GULF STATES UTILITIES COMPANY

February 17, 1984

River Bend Station - Units 1 & 2
Docket Nos. 50-458/50/459

Enclosed are Gulf States Utilities Company's (GSU) responses to the informal questions raised by reviewers from the Licensee Qualification Branch (LQB-RIV) based upon their review of the December 2, 1983 docketed letter from Mr. Booker to Mr. Denton. As a result of meetings between GSU and LQB-RIV on January 6, 1984, further clarifications with regard to the Final Safety Analysis Report (FSAR), Chapter 13, were necessary to complete input to the Safety Evaluation Report (SER). Attachment 1 summarizes these clarifications and references where the response is provided. Enclosure 1 provides the changes to the FSAR which will be included in the next amendment.

Figure 13.1-1a
Corporate Structure
Gulf States Utilities Company

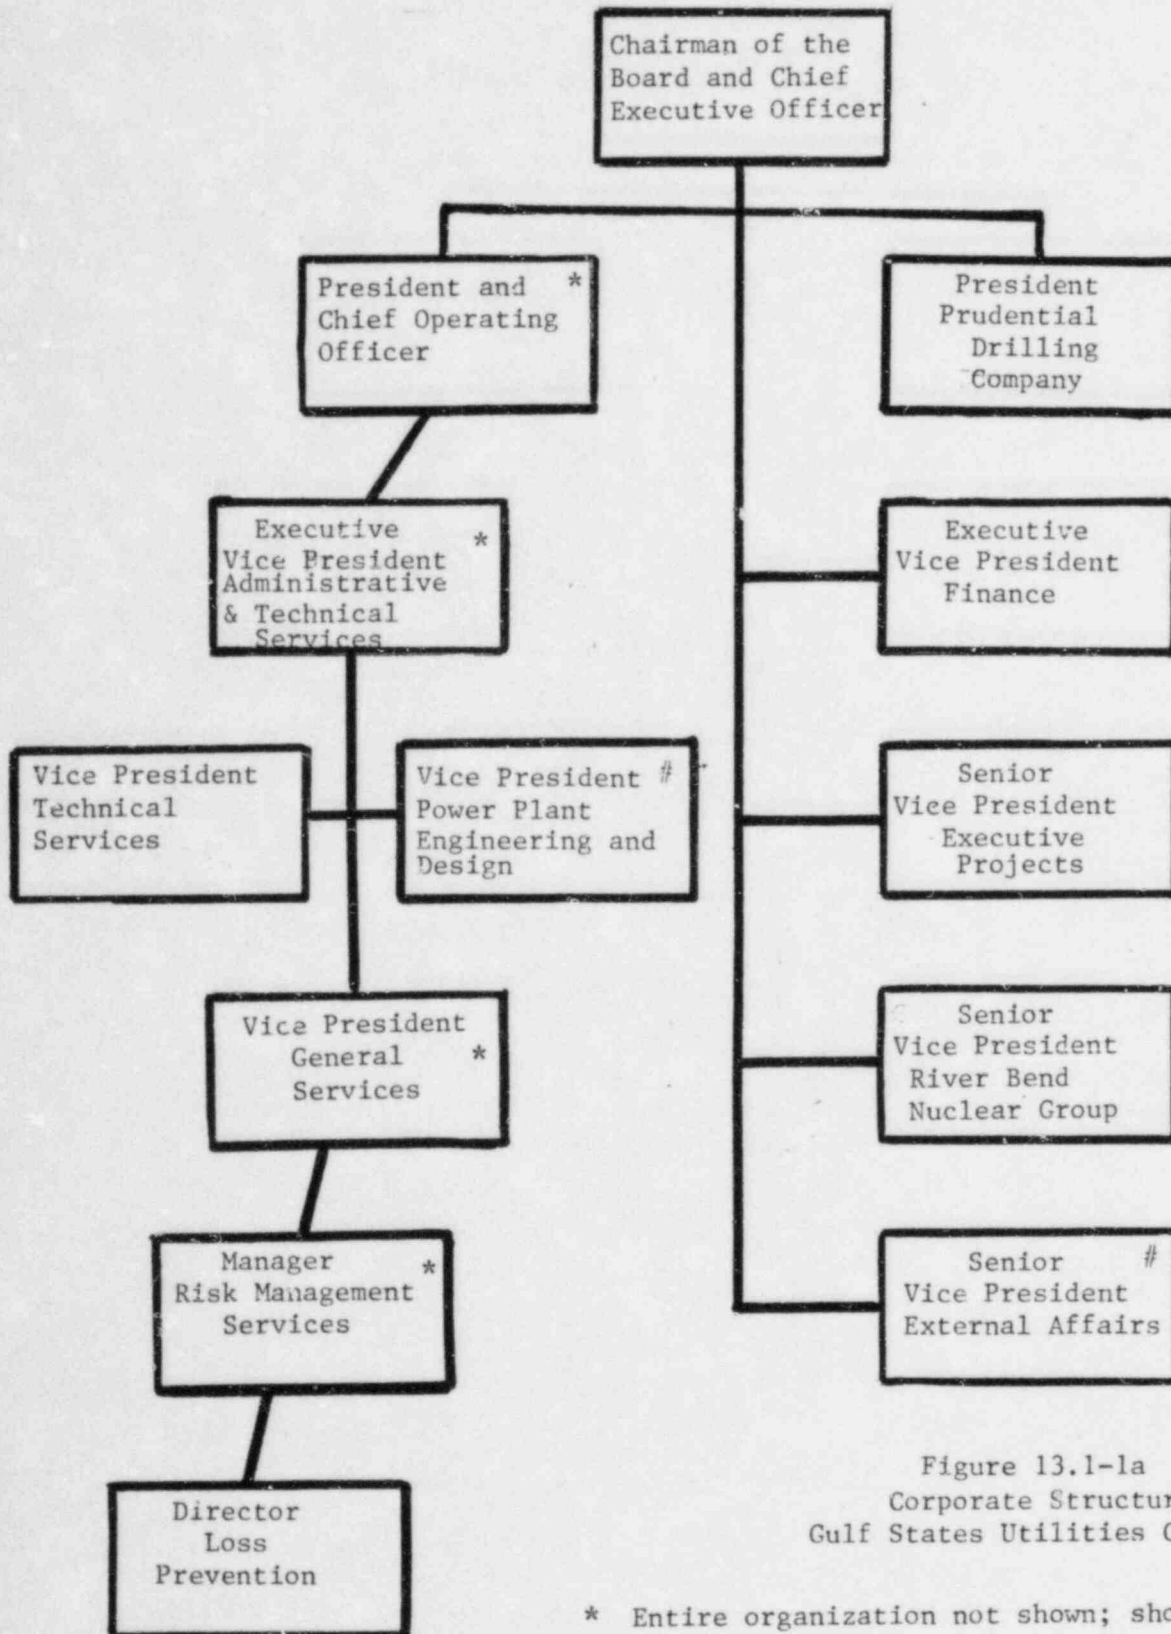
The Staff requested a sufficiently detailed description of the corporate organization to understand the position of individuals and organizations which interface with or provide technical support for the nuclear group.

See revised Section 13.1.1.1.3 and Figure 13.1-1a.

Figure 13.1-2a
Plant Operations Structure
Administrative Services Section
River Bend Station-Unit 1

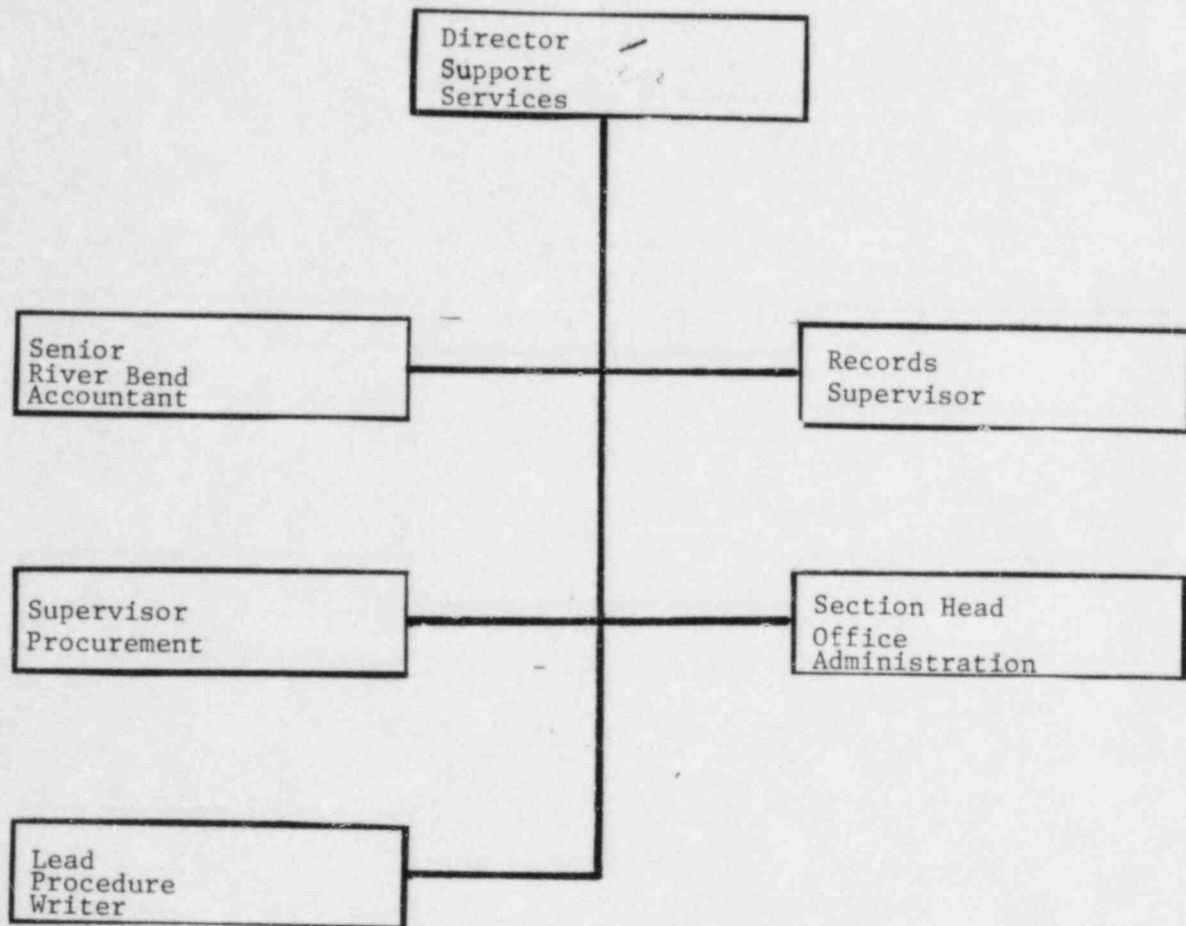
The Staff requested FSAR organizational charts and text to fully described the Nuclear Operations organization, including the Training Staff's size and minimum qualifications.

See revised Section 13.1.1.2.1.3 and Figures 13.1-2a and 13.1-2b for descriptions of the Nuclear Operations organization; the Training Staff's minimum qualifications will be addressed in a future submittal.
